## DRAFT COMPLETION REVIEW REPORT

**Licensee:** Rio Grande Resources Corporation (RGR)

**Radioactive Material License (RML) Number:** R06063

**Facility Name:** Panna Maria In-Situ Recovery (ISR) Plant

Figure 2. Proposed ISR Processing Facility (R06063) Location

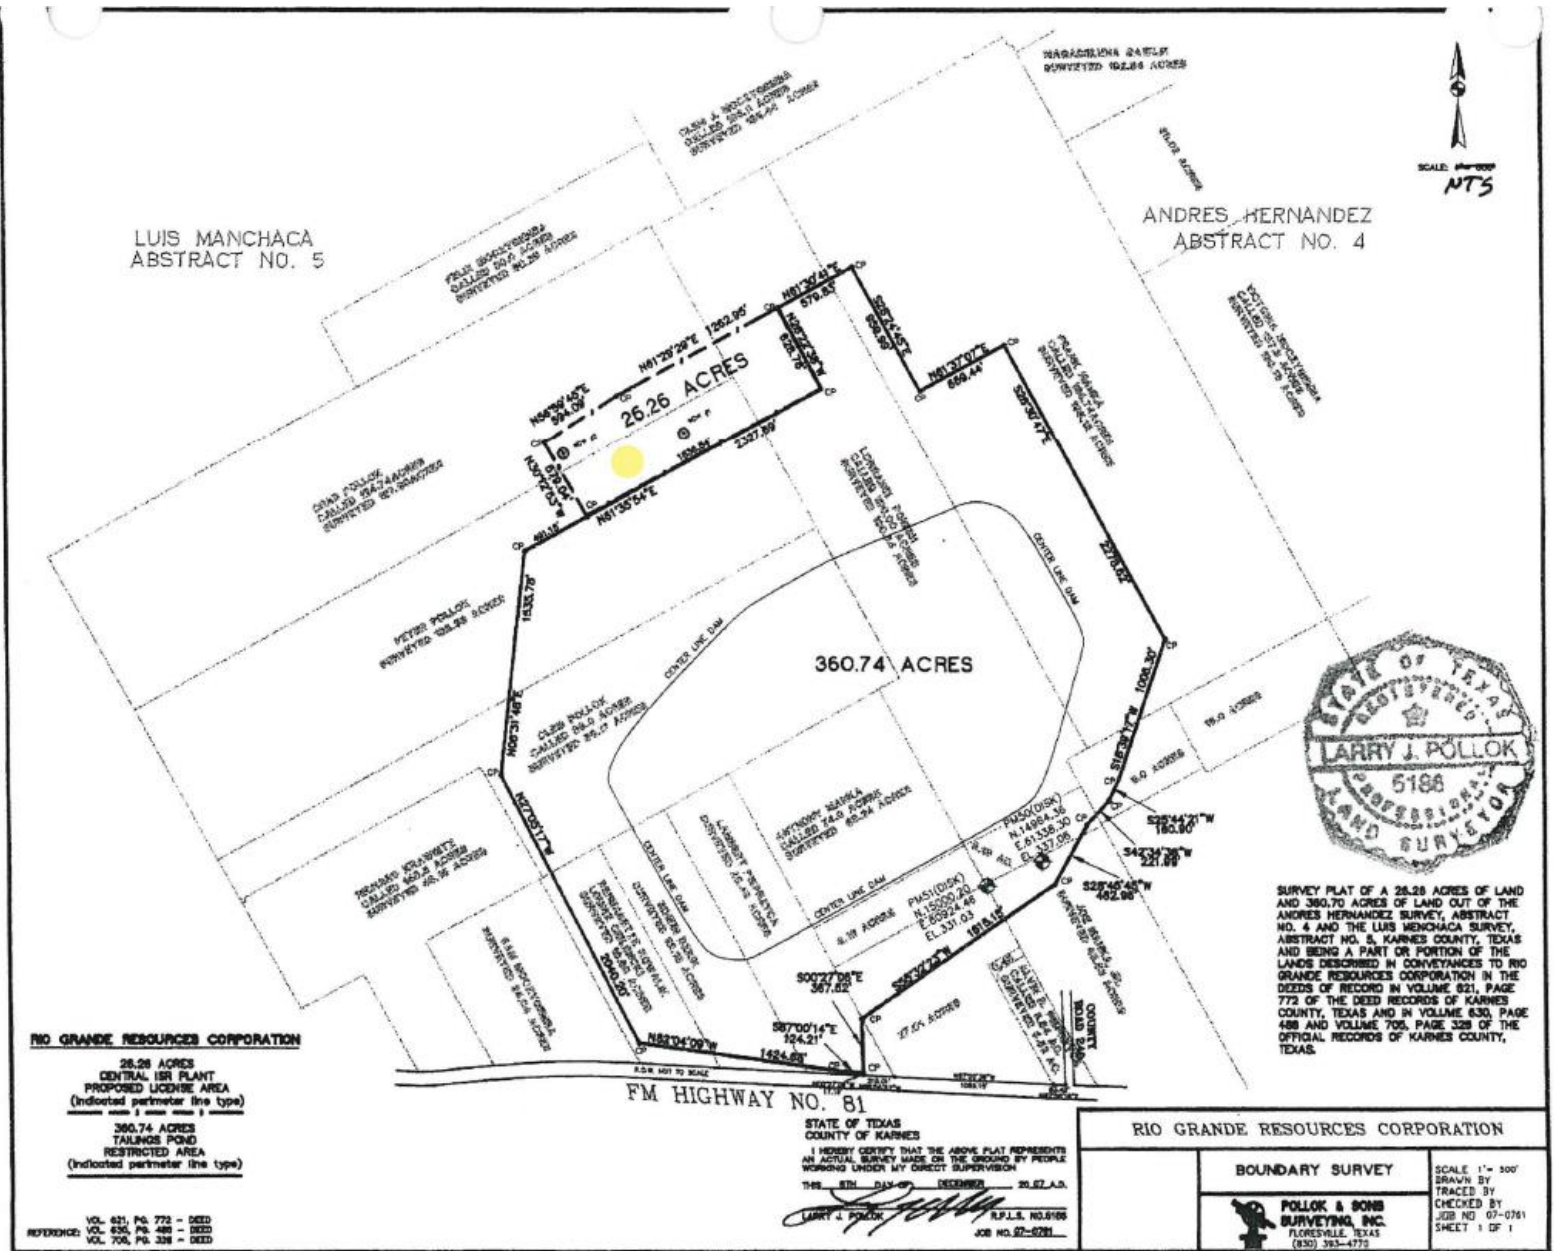
**Photo Description:** Photograph documents the area of the proposed processing facility authorized under R06063. The investigators observed no activities taking place related to the authorization.
